MILITARY SPECIFICATION

MODULES, STANDARD ELECTRONIC

RELAY, DPDT, POWER, KEY CODE NPM

This amendment forms a part of Military Specification MIL-M-28787/38B(EC), dated 14 November 1978, and is approved for use by the Naval Electronic Systems Command, Department of the Navy, and is available for use by all Departments and Agencies of the Department of Defense.

FIGURE 5. Open contact resistance test circuit for table III.

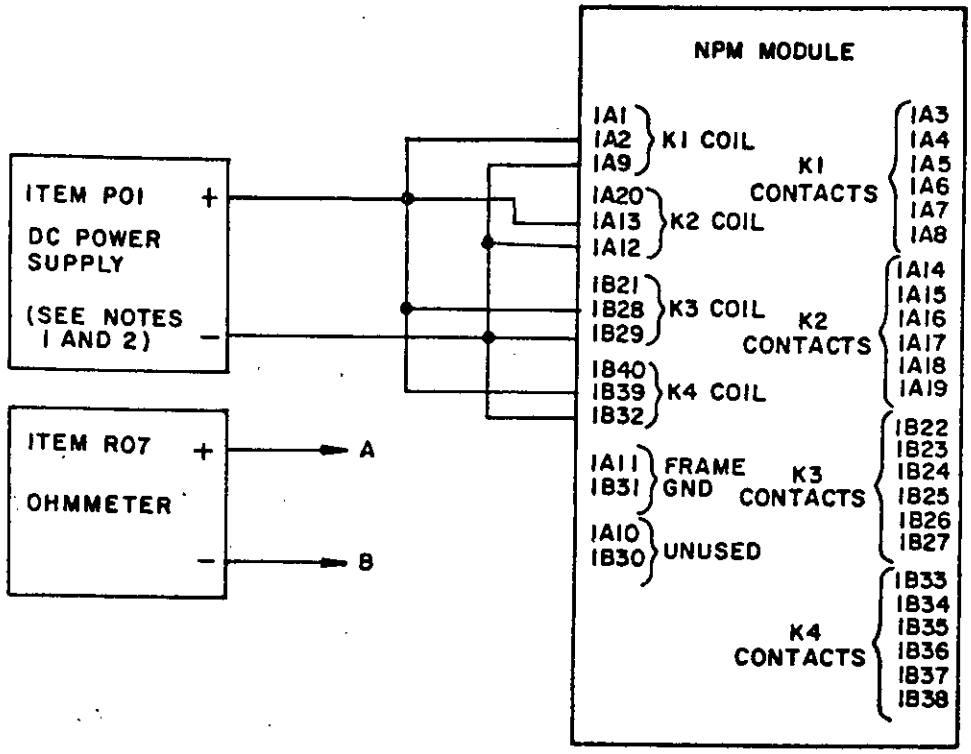
FIGURE 5: Delete and substitute new figure 5 as printed on page 2 of this amendment.

NOTES:
1. For measurement of test conditions B1-B8, item P01 shall be adjusted to 0.8 ±0.1 Vdc.
2. For measurement of test conditions B9-B16, item P01 shall be adjusted to 4.5 ±0.1 Vdc.
